RE: 657-703 Mamre Road, Kemps Creek (SSD-9522) Modification 2 – Response to Submission - Transport Statement

TABLE 1: RESPONSE TO TFNSW'S COMMENTS

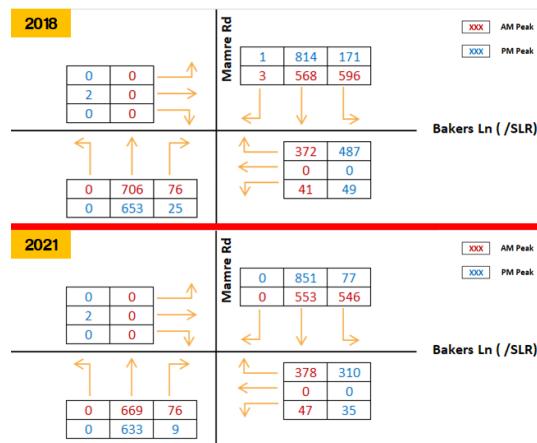
Item	TfNSW's Comments	Ason Group's / MU Group's Response
Road Design		
1	TfNSW has reviewed the designs of both Sequence 1A Modified and Sequence 1B to understand what the risks are should Sequence 1B not be constructed. TfNSW raises the following issues to the Department with Sequence 1A Modified which would be eliminated with the provision of Sequence 1B:	It should be noted that the detailed design for Modified Sequence 1A has been developed in accordance with the Austroads Guide and relevant TfNSW Supplements and Specifications. A Road Safety Audit (RSA) has also been conducted on the detailed design, in accordance with TfNSW Guidelines to Road Safety Audit Practices, with incorporations of the appropriate corrective actions. TfNSW's design review comments have also been incorporated in the development of the design (currently in the 100% detailed phase).
2	i. The "one lane to two lanes" and "two lanes to one lane" merging and diverging manoeuvres in close proximity to one another have been shown to create queuing. (examples are westbound on the G.W.H. west of Katoomba and eastbound on the G. W. H. approaching Mount Victoria/Blackheath also the M1 north and south of Sydney during the holiday periods).	The baseline traffic volumes on the Mamre Road / Bakers Lane intersection for the surveyed year 2018 and 2021 are shown in the figure overleaf.

Based on the figure above, the total traffic volumes heading northbound / southbound on Mamre Road are summarised as follows:

Traffic Volumes on Mamre Road		
Peak Hour / Direction	NB (veh)	SB (veh)
2018		
AM Peak	1,078	609
PM Peak	1,140	863
2021		
AM Peak	1,047	580
PM Peak	943	886

In this regard, it is important to give consideration to the existing capacity of Mamre Road with one lane, regardless of the development traffic. With reference to Section 4.2.3 of the TfNSW (formerly RTA) Guide to Traffic Generating Developments, the existing link Level of Service (LoS) along Mamre Road is shown in below table:

SIDRA Movement Summary for Approved Sequence 1B (2025) With and Without Development Traffic at the Mamre Road / Bakers Lane Intersection (in Isolation)

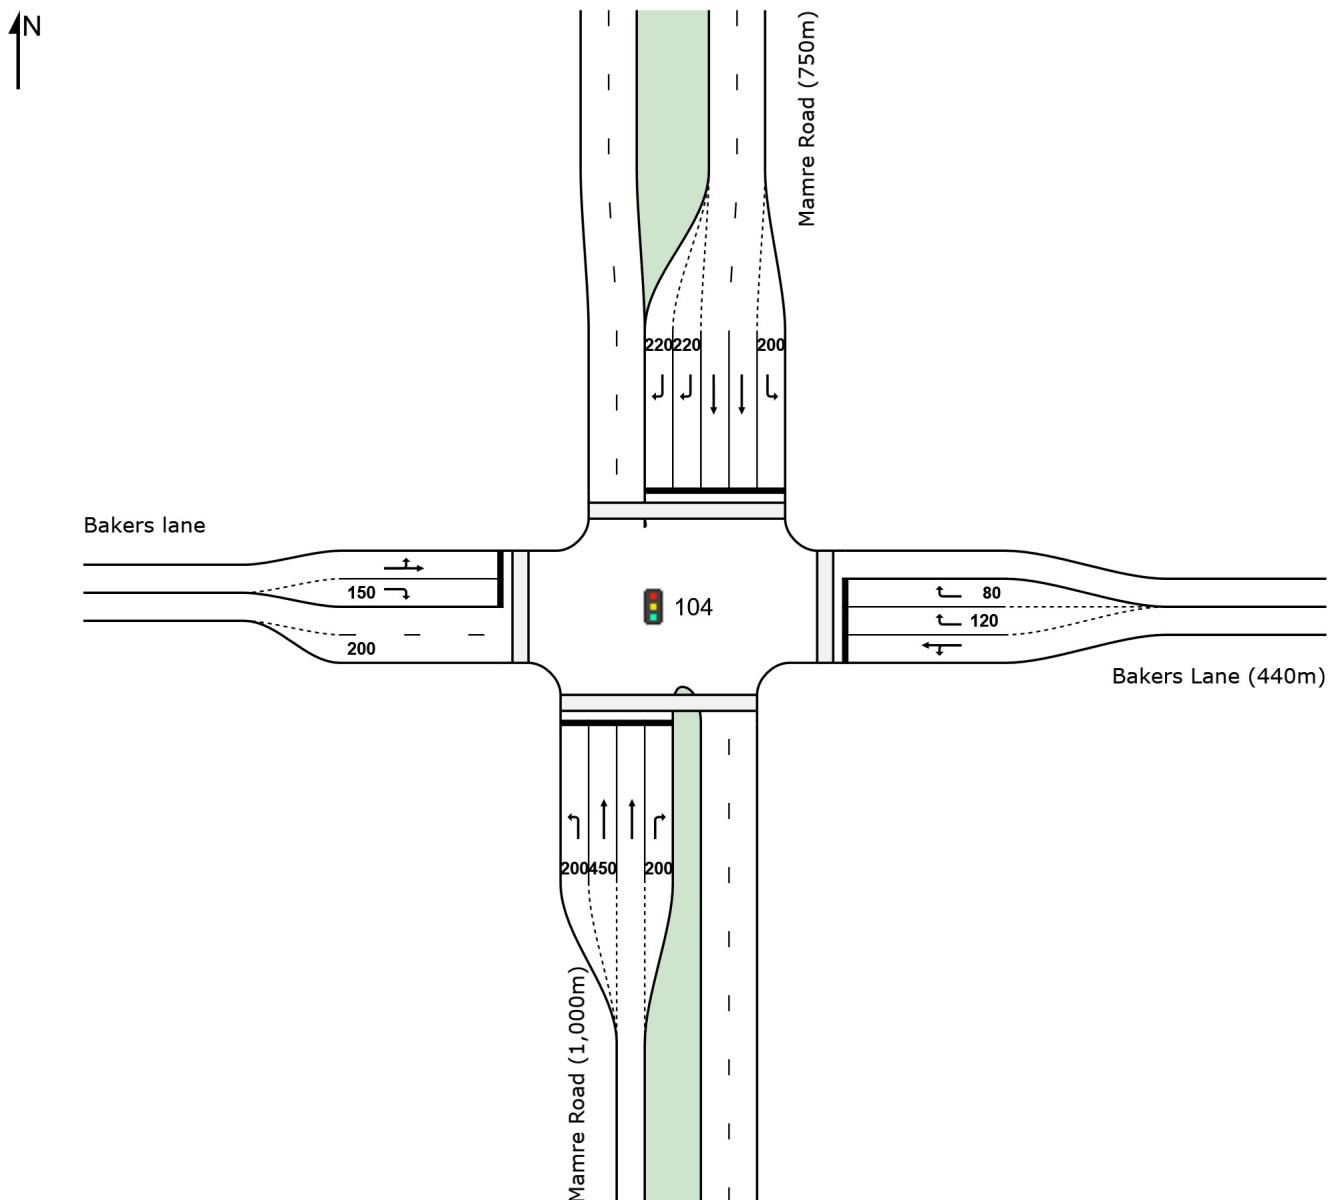
13	It is recommended that the SIDRA movement summaries for Sequence 1B are provided for review and comparison. All movement summaries should be provided for any updated modelling.	<p>The SIDRA movement summary for Sequence 1B has already been provided to TfNSW for review.</p> <p>However, this movement summary has been attached again within Attachment D.</p>
14	It is difficult to compare the results and determine whether there is any significant impacts to the signal operation should Condition B11 be removed. The following observations are made in abeyance of the requested model:	Noted.
15	<p>2026 Modified Sequence 1A</p> <p>i. Mamre Rd & Bakers Ln</p> <ul style="list-style-type: none"> • Intersection of Mamre Road & Bakers lane appears to perform worse without Sequence 1B (based on 2025 Sequence 1B with SL); • AM Peak – 	It is important to clarify that as acknowledged by TfNSW, this intersection would operate at a LoS C or D at the AM and PM Peaks respectively for the modelling horizon, 2026.

SIDRA Movement Summary of Amended Modified Sequence 1A (Two Lane Approach at Distribution Drive) at the Mamre Road / Distribution Drive and Mamre Road / James Erskine Drive Intersections

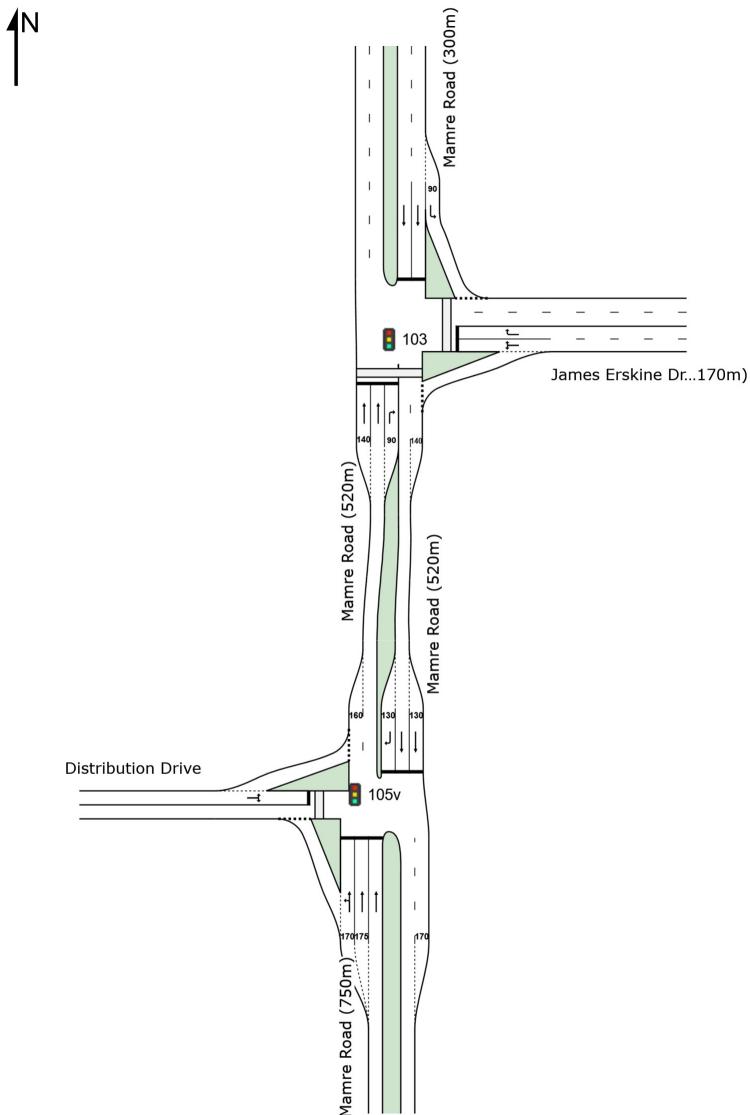
16	<p>ii. Appendix 8 – TIA (P1780r01v7 TN_Kemps Creek SSD 9522 MOD 2)</p> <ul style="list-style-type: none"> The SIDRA Network layout in Figure 8 appears to indicate that under Modified Sequence 1A, the section of Mamre Road between Distribution Drive (Mamre West precinct access) and James Erskine Drive is two lanes in each direction. However, the existing section is only one lane in each direction. This needs to be updated to reflect the actual lane arrangement. 	<p>It is important to emphasise that under the Stage 2 Mamre Road upgrade work, this section of the road (from Distribution Drive to James Erskine Drive) is expected to be upgraded by TfNSW (not as part of the SSD approval conditions). Hence, it makes sense to model this section as two lanes, noting future upgrades in the area. However, since the timing for the Stage 2 upgrade work has not been determined yet, we have undertaken an Option Testing to address this comment.</p> <p>Accordingly, the SIDRA Network layout has been amended to reflect TfNSW's request and the relevant movement summaries have been shown within Attachment E.</p> <p>Furthermore, as shown within Attachment E, the additional options testing indicates that Modified Sequence 1A (with one lane in both directions) operates at an acceptable LoS.</p>
